Transmission Expansion Advisory Committee Supplemental Projects

PPL Transmission Zone

Scope Change

Supplemental #: S0866 (2015 TEAC)

PPL Transmission Zone: Supplemental Martins Creek, PA

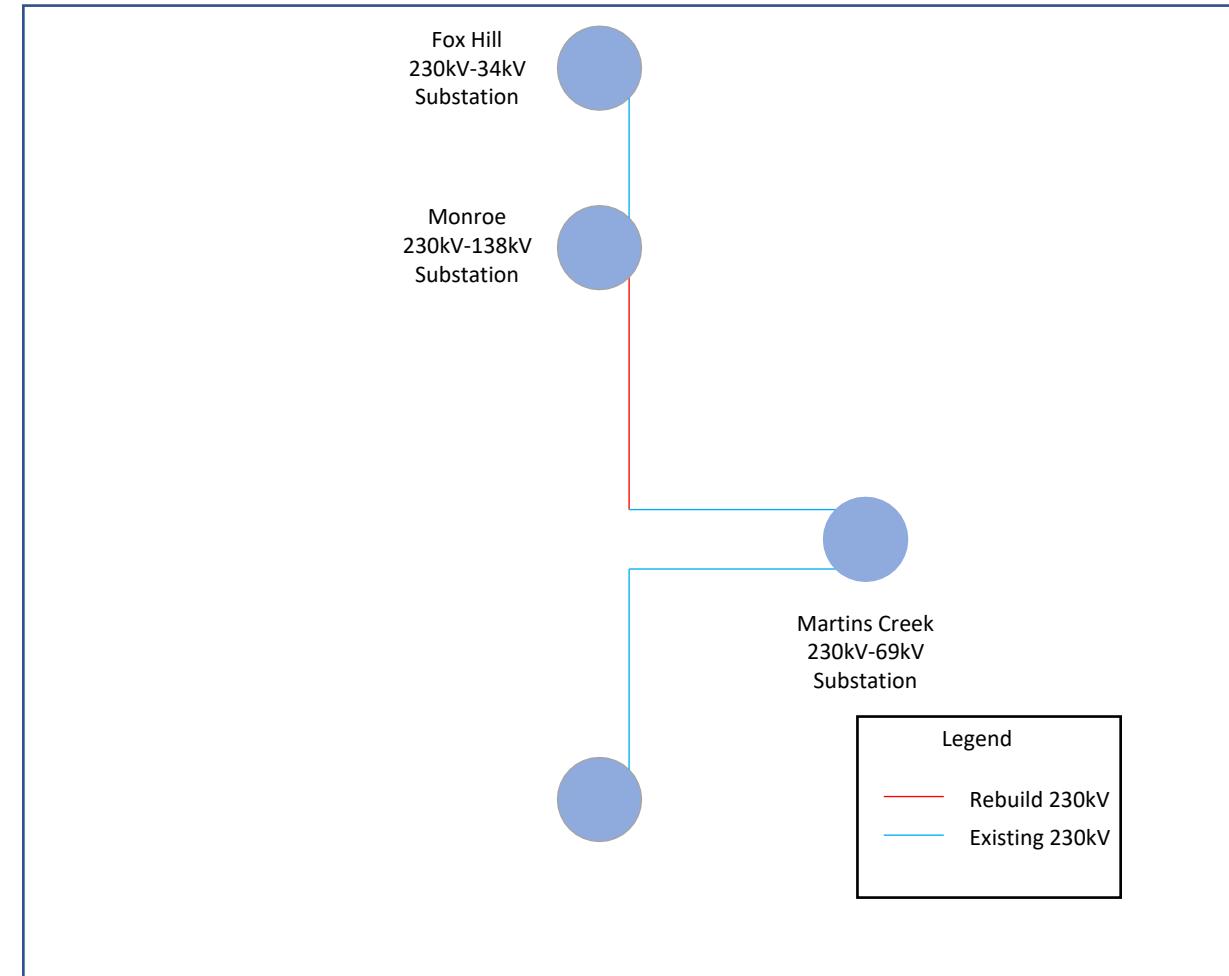
Original Scope: Build a new 230 kV circuit from Martins Creek to Monroe using existing Martins Creek-Stroudsburg 69 kV decommissioned line and reconfigure Martins Creek and Monroe substations.

Revised Scope: Rebuild the 15.75-mile-long 1926 tower section of the existing Martins Creek – Monroe 230kV line.

Estimated Project Cost: ~~\$44.86M~~ **\$66.9M**
